SERVICE BULLETIN NO. 120

Throttle Control Inspection

AA1-0001 thru AA1-0436. All spares stock of part nos. 507002-1 and 507002-2 throttle control.

Figure 1. Throttle Control Bulkhead Fitting

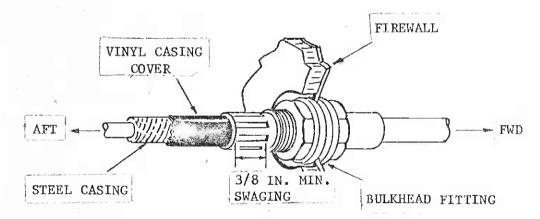
It has come to our attention that some part nos. 507002-1 or 507002-2 throttle control assemblies may have been improperly swaged at the firewall bulkhead fitting. (see figure 1) Improper swaging of this assembly can result in separation of the outer casing from the bulkhead fitting and subsequent partial loss of throttle control due to the outer casing sliding out of the bulkhead fitting when the throttle is opened.

- 1. Remove right hand forward console panel and locate the point where the throttle control cable passes through the firewall.
- 2. Measure the length of the swaging marks on the aft end of the firewall bulkhead fitting as shown in figure 1. If the swaging is less than 3/8 inches the cable must be removed from service.

3. Check the security of the swaged assembly by grasping the vinyl casing cover by hand as close to the bulkhead fitting as possible and pull straight aft on the cable assembly while twisting the cable back and forth. Do not bend or kink cable. The vinyl cover may slip out of the bulkhead fitting, but if the steel casing does not move, the cable assembly is satisfactory for continued service. If any motion between the steel casing and the firewall bulkhead fitting is noticed, the cable must be removed from service.

Figure 2.

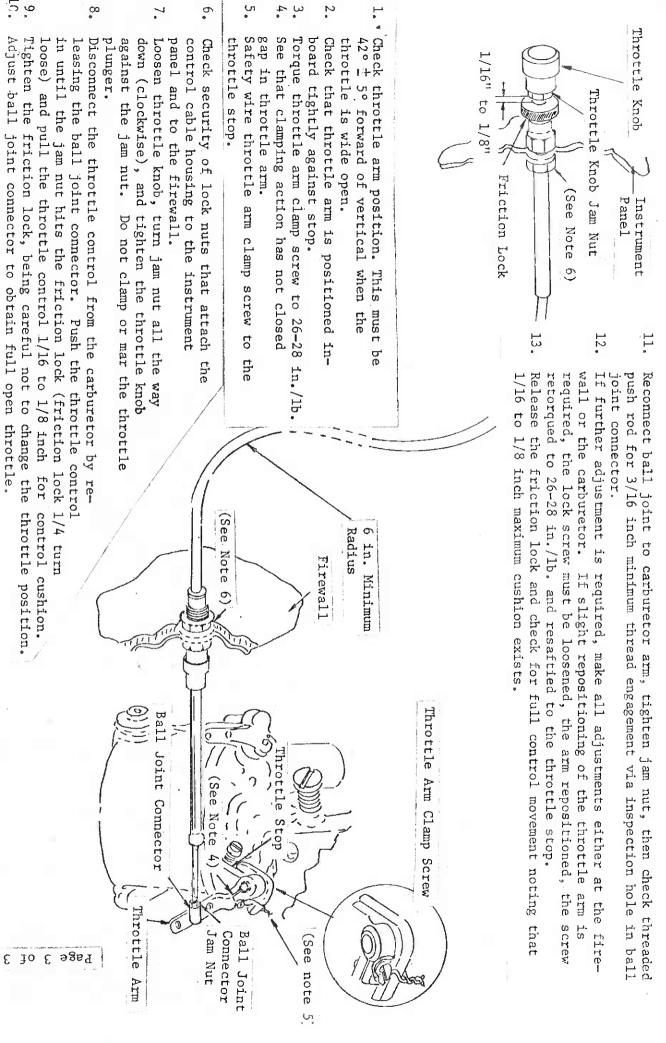
If inspection shows that the throttle control assembly must be replaced, rerigging of the throttle arm and cable must be accomplished as shown on figure 2.
